<b>Title:</b>  Comments on the Alaska Energy Authority's Initial Study Report and supplemental filings, Susitna-Watana Hydrologic Project No. 14241-000		<b>SuWa 295</b>
<b>Author(s) – Personal:</b> Mike Wood (Susitna River Coalition) Whitney Wolff (Talkeetna Community Council) Judy Price (Alaska Survival) Ellen Wolf (Talkeetna Defense Fund) Ryan Schryver (Alaska Center) Sam Snyder (Trout Unlimited) Emily Anderson (Wild Salmon Center) Sterling Miller (writer of the attachments)		
<b>Author(s) – Corporate:</b> (see list above)		
<b>AEA-identified category, if specified:</b>		
<b>AEA-identified series, if specified:</b>		
<b>Series (ARLIS-assigned report number):</b> Susitna-Watana Hydroelectric Project document number 295	<b>Existing numbers on document:</b> 20160624-5024 (FERC posting)	
<b>Published by:</b>	<b>Date published:</b> June 23, 2016	
<b>Published for:</b> Federal Energy Regulatory Commission	<b>Date or date range of report:</b>

**Re: Comments on the Alaska Energy Authority's Initial Study Report and Supplemental Filings, Susitna-Watana Hydrologic Project No. 14241-000**

On behalf of Susitna River Coalition, Talkeetna Community Council, Alaska Survival, Talkeetna Defense

**Figure 1. Estimated Horowitz-Thompson (H-T) detection probabilities for brown bears in the Large Carnivore Study area (extracted from Figure 5.1-7 of the Large Carnivore ISR, page 26, red line and text box added).**

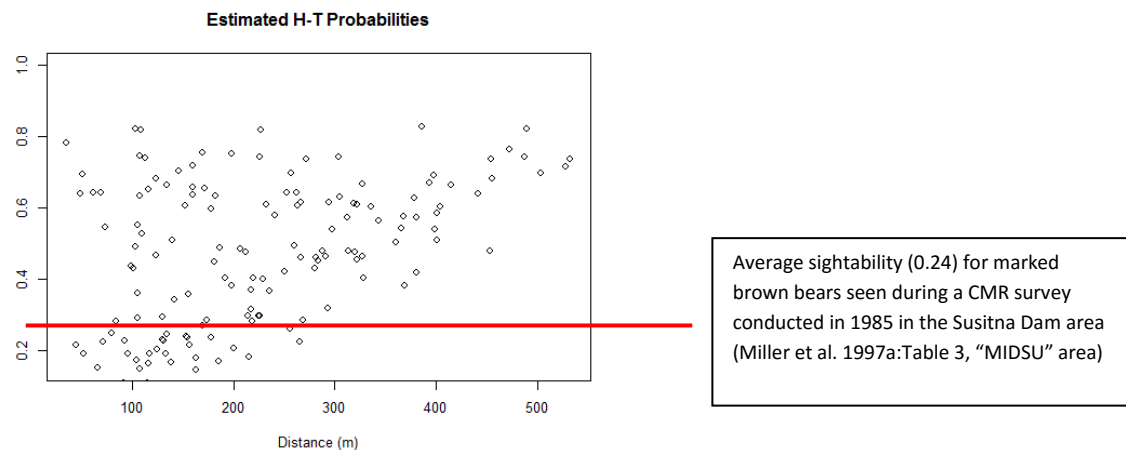
The calculated brown bear Horowitz-Thompson (H-T) detection probabilities for the MRDS surveys are shown in Figure 1. A red line displays the average sightability (24%) for a CMR study that was conducted in 1985 in the 1,317 km<sup>2</sup> study area used to estimate bear density (Miller 1987, sightability data in Miller et al. 1997a). Average sightabilities for many CMR studies in Alaska were presented by Miller (1997a:Table 3), and almost all of them are lower than the median detection probability for brown bears reported by AEA (0.485, ISR 10.8 Part A Page 8) (Figure 1). This comparison supports our suspicion that detection probabilities were overestimated in the MRDS technique reported by AEA (2014). This would have led to an underestimation of bear abundance.

E. Becker of ADF&G said that this comparison was invalid because detection probabilities for the MRDS technique were calculated differently than sightabilities for the CMR studies. Although calculated differently, for each of the detection probability points in Fig. 1, the likelihood that a particular bear would have been seen during a CMR survey flight would be higher. This is because of the higher search effort during CMR surveys. Additionally, the likelihood of any bear being seen in forested habitats that composed >50% of the Large Carnivore Study Area would be even lower than in the predominantly shrub habitats where the 24% sightability value was obtained during earlier Susitna studies (Miller 1987). Bears in these forested habitats would not only have detection probabilities less than the median of 0.48 reported in the ISR and illustrated in Fig. 1, the likelihood of observing these bears would be much less than the 24% found in the shrubby habitats of the 1985 Susitna study area.
